POWER DISTRIBUTION LIMITS3/4.2.3 RCS FLOW RATE AND NUCLEAR ENTHALPY RISE HOT CHANNEL FACTORLIMITING CONDITION FOR OPERATION

ATTACHMENT 2

REACTOR COOLANT SYSTEM (RCS) FLOW RATE MEASUREMENT

ATTACHMENT 3

Figure 3.2-3 RCS FLOW RATE VERSUS R

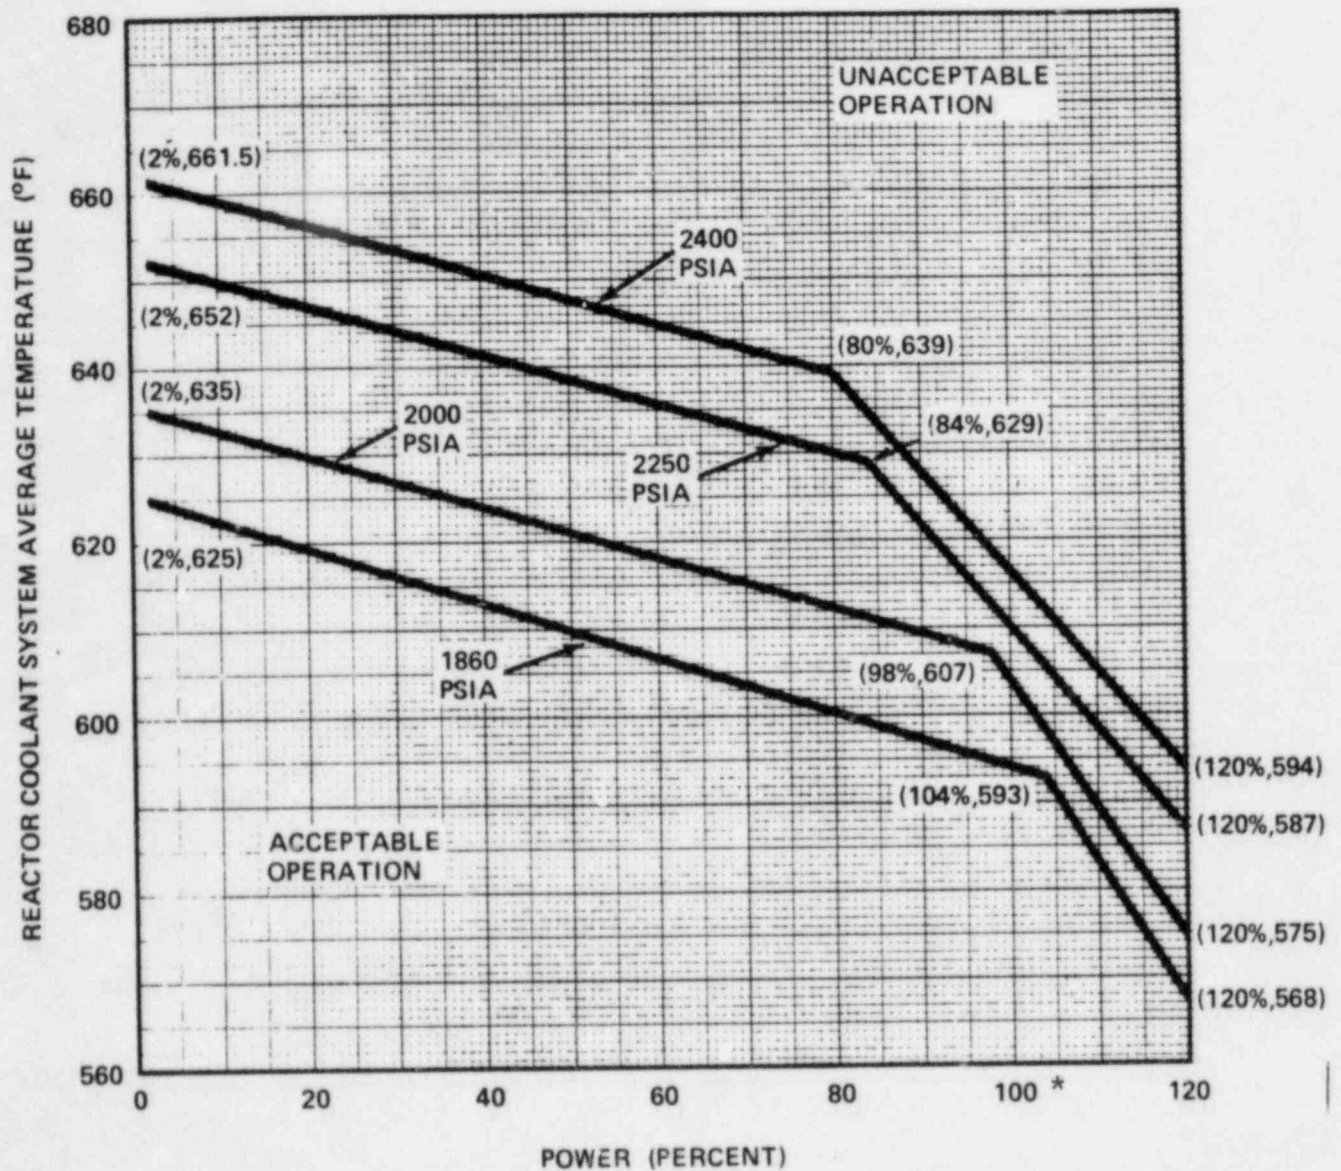
Based on a conservative assumption that the measured RCS flow will be no lower than 95% of TD flow, it is requested that a region of acceptable operation be added to Figure 3.2.3 for:

$$95\% \text{ TD Flow} \leq \text{RCS Flow} \leq 100\% \text{ TD Flow}$$

Considering the relationship given by Equation 3, it is recommended that the maximum power level for this region be reduced by 2% for each 1% reduction in measured flow below TD flow. This conservative restriction of core power is the equivalent of an RCS flow increase ranging from approximately 2.6% - 13.0% in terms of DNB margin for flow deficits up to 5%. Operation of the plant in this region within the specified power restriction does not result in increased T_{avg} , thus there is no temperature impact on the DNB margin.

The proposed change to Figure 3.2-3 to account for a reduction in measurement uncertainties (3.5% to 2.0%) for RCS flow has no effect on the Thermal Design flow. The Thermal Design flow which is utilized in the various safety analyses remains unchanged. In regard to the change which defines allowable power levels for an RCS flow rate less than 100% of Thermal Design flow, thermal-hydraulic sensitivity studies have shown that this power/flow tradeoff is conservative with respect to DNB margin.

NOTE: When operating in Region III, the restricted power levels shall be considered to be 100% of Rated Thermal Power (RTP) for Figure 2.1-1.

If the measured RCS flow is equal to or greater than TD flow, operation will be in the acceptable region of the present Figure 3.2-3 and the requirements of this specification will remain unchanged. The addition of the new region to Figure 3.2-3 is only requested to preclude a needless reduction to 5% RTP should the measured RCS flow be less than TD flow.

FIGURE 1

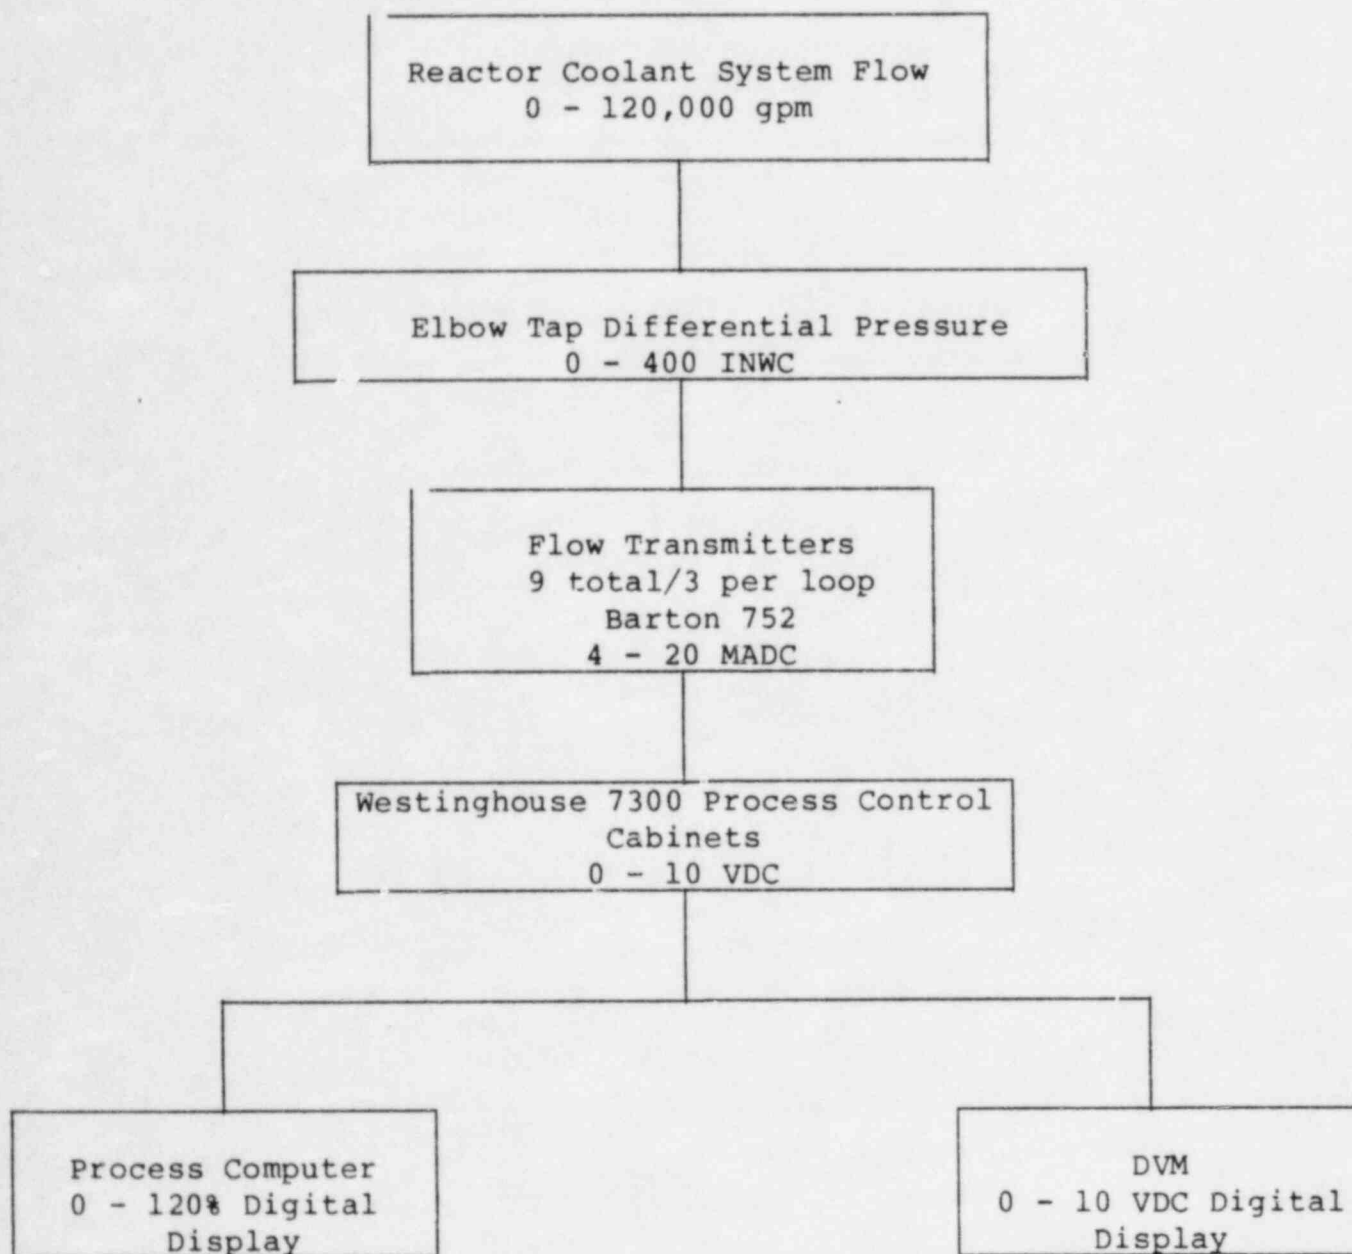
the elbow tap flow indication is depicted in Figure 1. Table 2 provides the list of components involved in the precision calorimetric flow calculations. The overall loop flow measurement uncertainty is the statistical summation of individual uncertainties (accounting for interactive effects where necessary) and appears at the bottom of Table 2
